# Access Compliance Report

## Public Rights-of-Way

Intersection ID: 48197	Main Street: ARDREY_KELL_DR	Cross Street: BLANKENEY_PARK_DR	Location: NW
ADA ID: 1356C693E01A	Ramp Type: PerpDiag	Initial Pass/Fail: Fail	Overall Compliance: No
Severity Score: 42.5			
Codes/Mitigation Info/Possible Solution		Field Measurements/Component Compliance

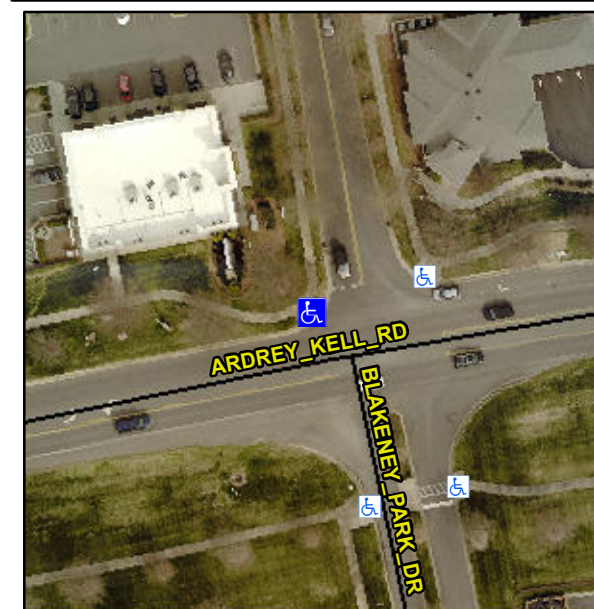
**R304.5.1, R304.2.2**

Compliance	Description	Data	Compliance	Description	Data
N/A	Ramp Length (in)	72.0	No	Ramp Slope (%)	13.3
No	Ramp Width (in)	35.0	Yes	Ramp XSlope (%)	0.6
N/A	Flare Type LT	N/A	N/A	Flare Type RT	N/A
N/A	Flare Slope LT (%)	N/A	N/A	Flare Slope RT (%)	N/A
N/A	Flare Traversable LT?	N/A	N/A	Flare Traversable RT?	N/A
N/A	Landing Length (in)	N/A	N/A	DWS Provided?	N/A
N/A	Landing Width (in)	N/A	N/A	DWS Contrast?	N/A
N/A	Landing Slope (%)	N/A	N/A	DWS Length (in)	N/A
N/A	Landing X Slope (%)	N/A	N/A	DWS Full Width?	N/A
N/A	Landing Curb? (Y/N)	N/A	N/A	DWS Offset (in)	N/A
N/A	Shared Landing?	N/A			
N/A	Gutter Ponding?	N/A	N/A	Gutter Slope (%)	N/A
N/A	Gutter Lip Ht (in)	N/A	N/A	Gutter X Slope (%)	N/A
N/A	Painted X Walk1?	No	N/A	Painted X Walk2?	No
	X Walk 1 Direction	To S		X Walk 2 Direction	To E
N/A	X Walk 1 Width (in)	N/A	N/A	X Walk 2 Width (in)	N/A
	X Walk 1 Slope (%)	4.0		X Walk 2 Slope (%)	2.6
	X Walk 1 X Slope (%)	2.7		X Walk 2 X Slope (%)	1.3

**Remove & Replace Curb Ramp With Two New Directional Ramps or Equivalent.**
